# Access Compliance Report
Public Rights-of-Way
(Curb Ramps)

Intersection ID: 28662	Main Street: MEADOWMONT_DR	Cross Street: MEADOWMONT_VIEW_DR	Location:	N
ADA ID: 5C4F62BC5676	Ramp Type: BlendTrans1	Initial Pass/Fail: Fail	Overall Compliance: No	Severity Score: 8.75

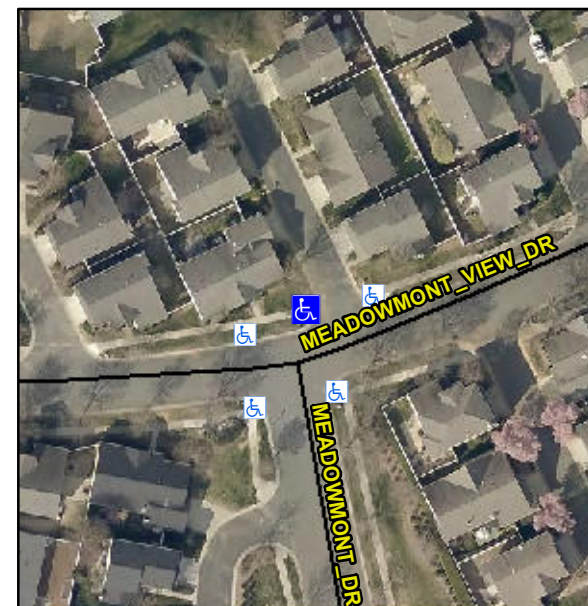
Not Found, R304.5.1

Remove & Replace Curb Ramp With Two New Directional Ramps or Equivalent.
